**LIGO-BEAM TUBE**  
 HANFORD, WA & LIVINGSTON, LA

TUBE SECTION LEAK TEST  
 BLIND END HEAD SUPPORTS

Dwg. ER214 Rev. I

LIGO-D970025-01-13

Rolling Frame (Blind End)

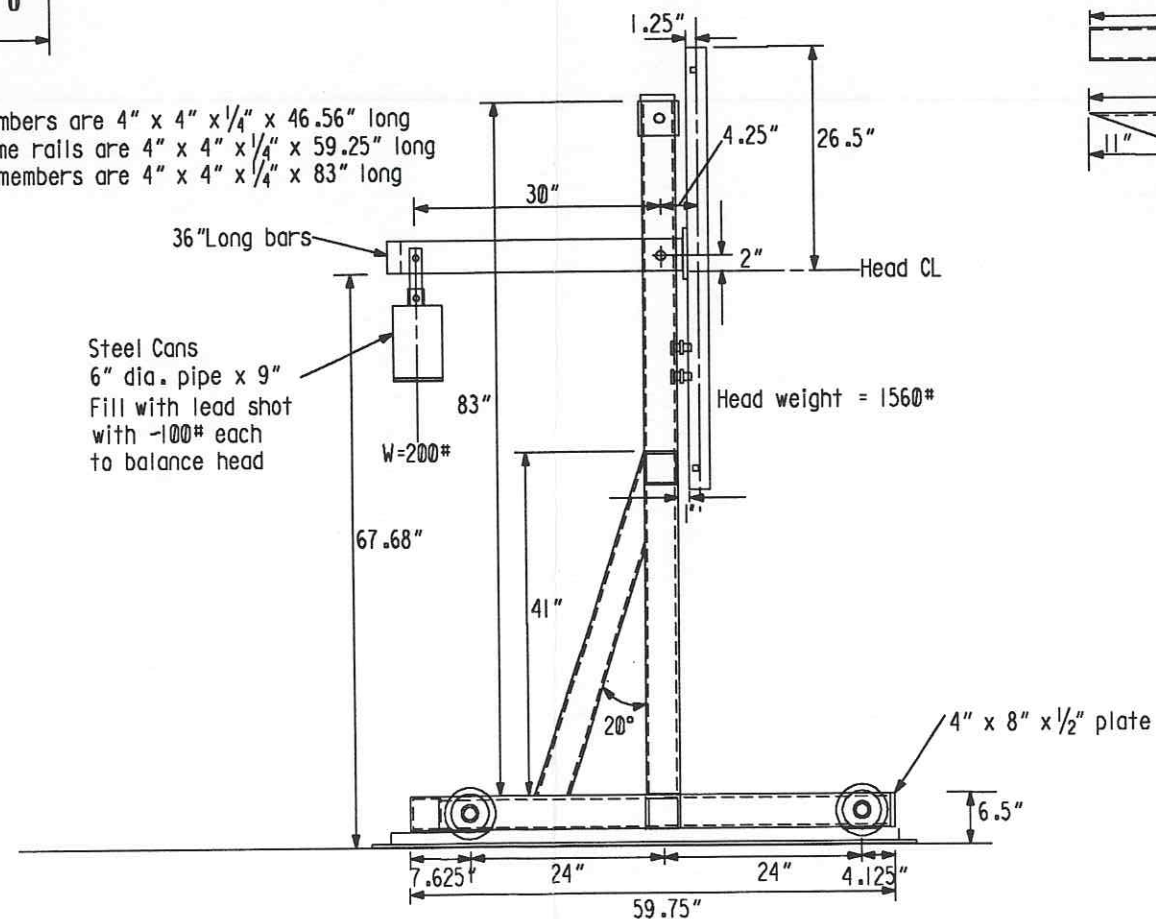
REV	DATE	BY	CHKD	DATE	REVISIONS
1	10-10-96				REV'D ROLLING FRAME DIM.

Cross members are 4" x 4" x 1/4" x 46.56" long  
 Main frame rails are 4" x 4" x 1/4" x 59.25" long  
 Vertical members are 4" x 4" x 1/4" x 83" long
